City of Santa Fe, New Mexico

memo

2025-010490-HDRB, 815 E. Alameda St. Unit 8, Downtown & Eastside Historic District, William Kleinschmidt, agent for Nancy Abruzzo Holdings LLC, owner, proposes to construct a 2,204 sq. ft. freestanding residence to the maximum allowable height of 14'-5" and a 6'-0" high yard wall with 8' high gate enclosures where the maximum allowable height is 4'-6". An exception is requested to 14-5.2(D)(9)(c)(ii)(C) to exceed the maximum allowable height of the yard wall.

Figure 2: Proposed south (street facing) elevation

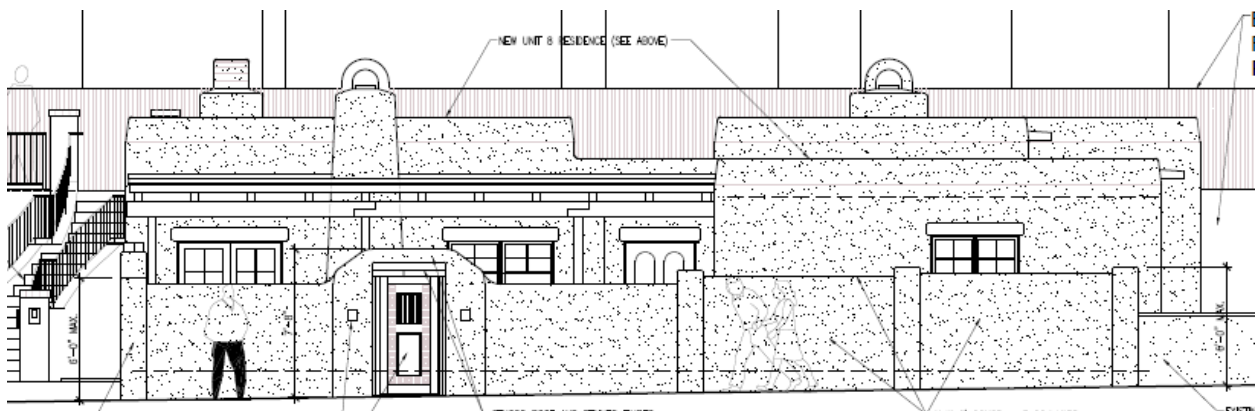
Staff finds that the exception criteria have not been met and recommends denial of the 6'0" high yard wall and gates, staff also finds that the 3'0" high publicly visible metal planter wall that extends for approximately half of the east elevation facade does not comply with the materials standards under section 14-5.2(E) Downtown and Eastside Historic Districts Standards as metal cannot simulate the appearance of adobe construction and recommends denial of the metal planter.

Staff Response: Staff find that this criterion is not met. The development of Sangria Compound Condominiums has 4’0” high yard walls. To have a single property with a 6’0” high yard wall would detract from the unity of the compound. This streetscape is along the river where there is an open park and trail area with no fences or yard walls. The north side of the street where the housing is has only low yard walls, where the average is 4’6”. A single property with a 6’0” high yard wall will impact and damage the character of the district, the streetscape, and the compound.

Staff Response: Staff find that this criterion is not met. There is no hardship to the applicant to construct what is consistent with the streetscape and the compound. All of the houses along Alameda have the same issues and low yard walls.

Staff Response: Staff find that this criterion is not met. A single 6’0” high yard wall in this streetscape does not strengthen but weakens the heterogeneous character of the city. Other designs could be considered.

Staff Response: Staff find that this criterion is not met. The compound is dense, but the residences' location is the same as those on this streetscape, and no property has 6'0" high yard walls. This height will not fit into the idea of openness that is a part of the Alameda streetscape.

Staff Response: Staff find that this criterion is not met. The Development Plan does not have a height requirement for walls and fences. This compound has street-facing walls at 3'0" to 4'0". A single property with a 6'0" high yard wall will impact and damage the character of the district, the streetscape, and the compound.

Staff Response: Staff find that this criterion is not met. The least negative impact for this property would be to construct consistently with the open feeling of the compound and the streetscape. The character of the streetscape is to be open, a 6'0" foot yard wall would not fit into this streetscape, it would have a stark negative impact.
